PUBLIC UTILITIES COMMISSION OF THE STATE OF CALIFORNIA

RESOLUTION E-5172

Resolution E-5172. Approval, with Modifications, of utilities' Advice Letters seeking proposed modifications to Electric Rule 21 Tariff in Compliance with Decision 20-09-035, Ordering Paragraphs 2, 6, 11, 12, and 23.

Appendix E: Interconnection Technical Framework Overview flow chart¹⁹⁷

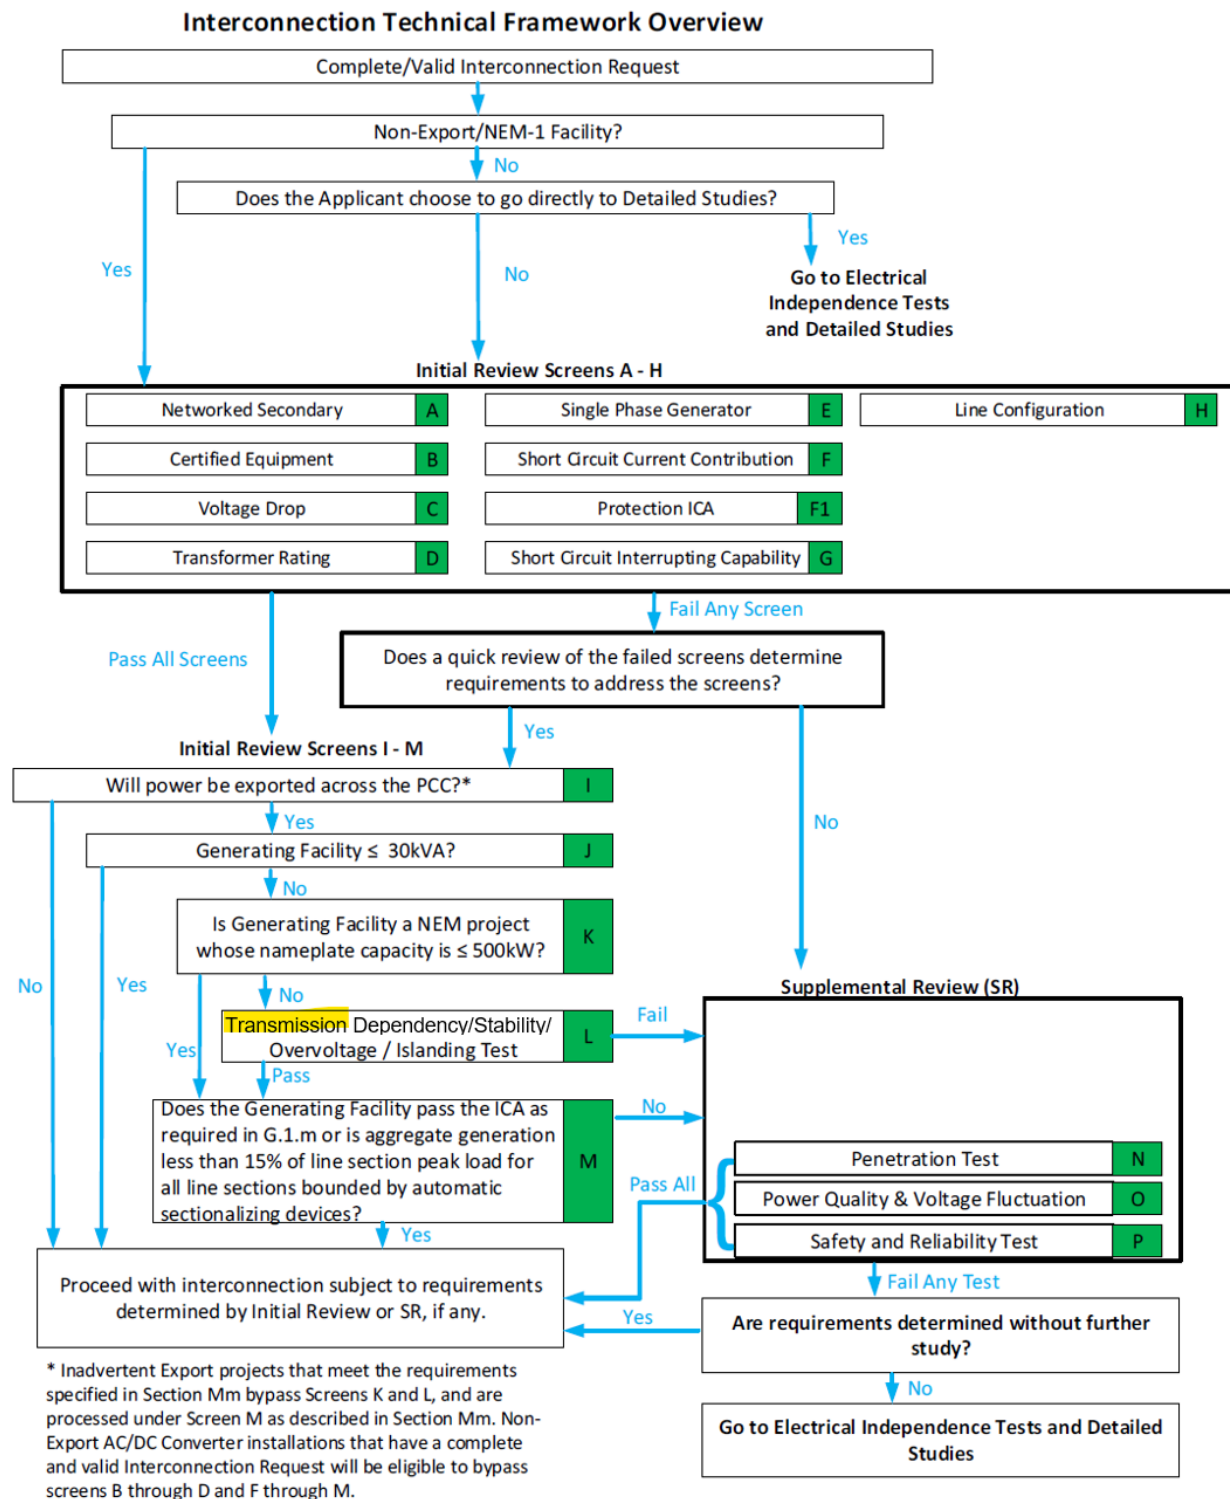
IREC indicates that “the IOUs propose three different notes to discuss non-export converters in the [Interconnection Technical Framework Overview] flowchart. IREC prefers a modified version of SDG&E’s language that uses defined terms, and capitalizes the defined terms. IREC proposes using a slightly modified version of SDG&E’s note in the flowchart, as follows:

Staff has reviewed PG&E’s AL 5915-E-B, SCE’s AL 4561-E-A, and SDG&E AL 3677-E-B. Within these documents, PG&E’s Interconnection Technical Framework Overview flowchart’s notes on non-export converters are different than SCE and SDG&E. PG&E corrected this note on the flowchart in its second substitute sheet as a supplement to Advice Letter 5915-E-B.

the tariff language in Appendix E of this Resolution in a Tier 1 compliance Advice Letter filing within 30 days. Appendix E contains slight modification of the flowchart included in the Utilities' supplemental Advice Letters and the minor edit on the flowchart serves to increase readability.

¹⁹⁷ The change in the flow chart is highlighted in yellow.
